ADDENDUM NO. 1

To: ALL PROPOSAL HOLDERS
FINANCIAL ITEM NUMBER: 43392715201
CONTRACT NUMBER: E3N17

DESCRIPTION: Approach slab replacement on SR 8 (I-10) Bridge Numbers 540006 and 540049 in Jefferson County.

Plans Revision Number 1:

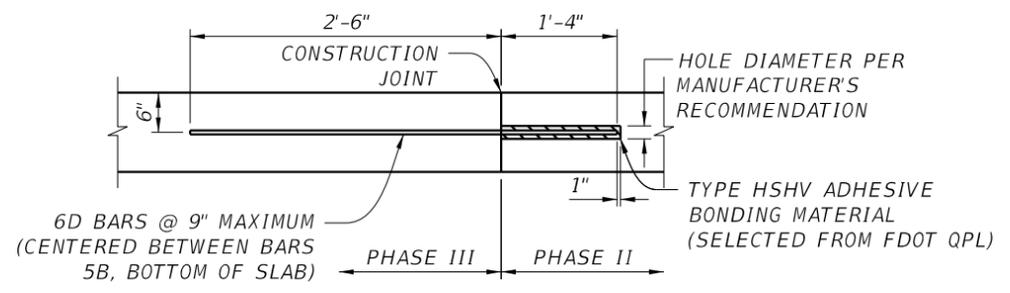
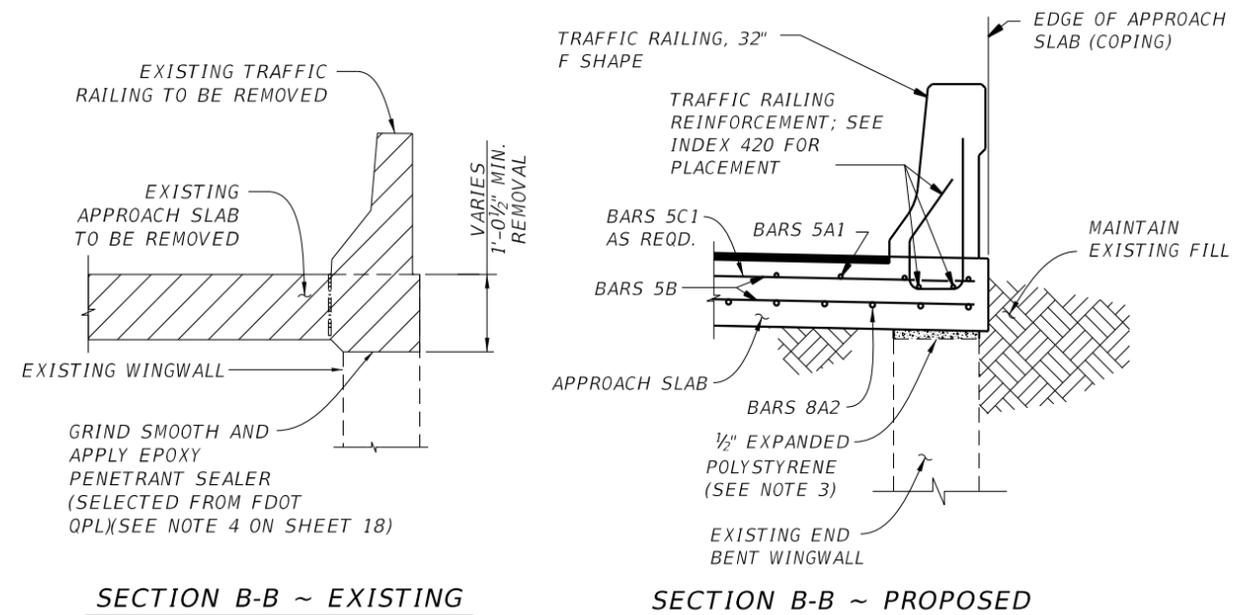
- **Sheet No. 1-Revise key sheet, add revision footnote.**
- **Sheet No. 2A-Add new signature sheet for this revision.**
- **Sheets 19 & 21-Added plan notes for Class II and Class IV concrete cure period clarification.**

12. THE CURE PERIOD FOR THE CLASS IV CONCRETE SHALL BE A MINIMUM OF 24 HOURS. CONCRETE IS TO ATTAIN A MINIMUM COMPRESSIVE STRENGTH OF 2,200 PSI PRIOR TO OPENING TO TRAFFIC.
13. THE CURE PERIOD FOR THE CLASS II CONCRETE (TRAFFIC BARRIER) SHALL BE A MINIMUM OF 24 HOURS. CONCRETE IS TO ATTAIN A MINIMUM COMPRESSIVE STRENGTH OF 2,500 PSI PRIOR TO OPENING TO TRAFFIC.

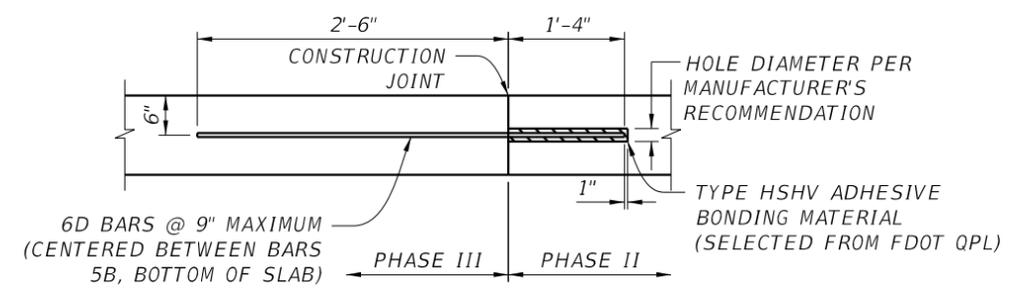
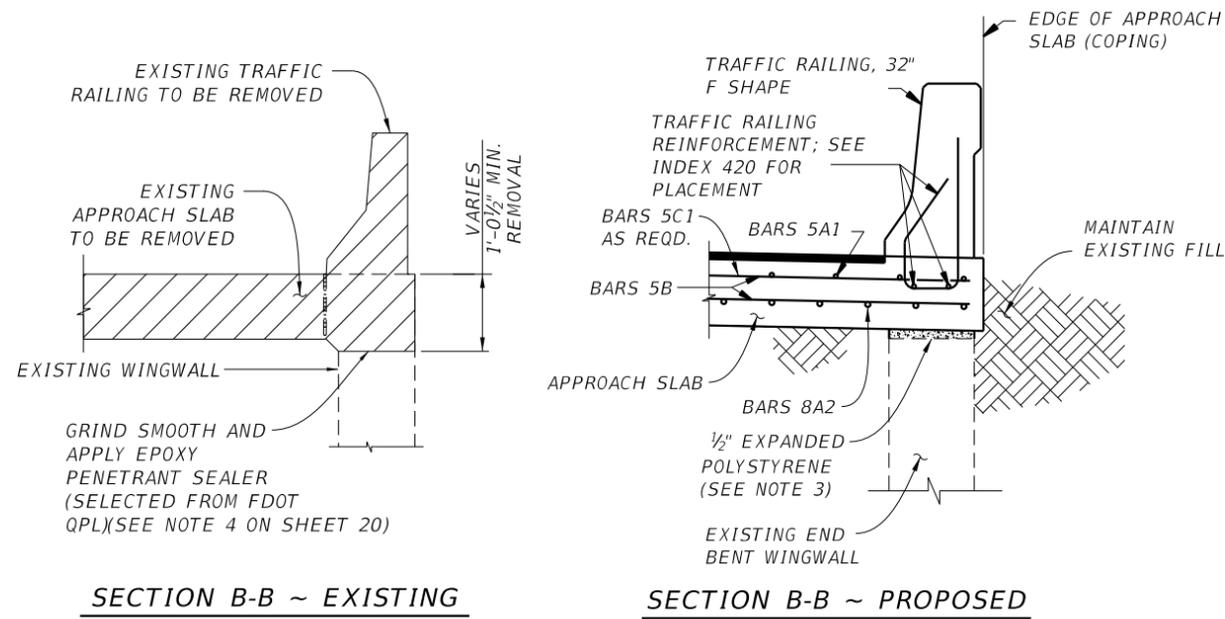
- THE CURE PERIOD FOR THE CLASS IV CONCRETE SHALL BE A MINIMUM OF 24 HOURS. CONCRETE IS TO ATTAIN A MINIMUM COMPRESSIVE STRENGTH OF 2,200 PSI PRIOR TO OPENING TO TRAFFIC.
- THE CURE PERIOD FOR THE CLASS II CONCRETE (TRAFFIC BARRIER) SHALL BE A MINIMUM OF 24 HOURS. CONCRETE IS TO ATTAIN A MINIMUM COMPRESSIVE STRENGTH OF 2,500 PSI PRIOR TO OPENING TO TRAFFIC.
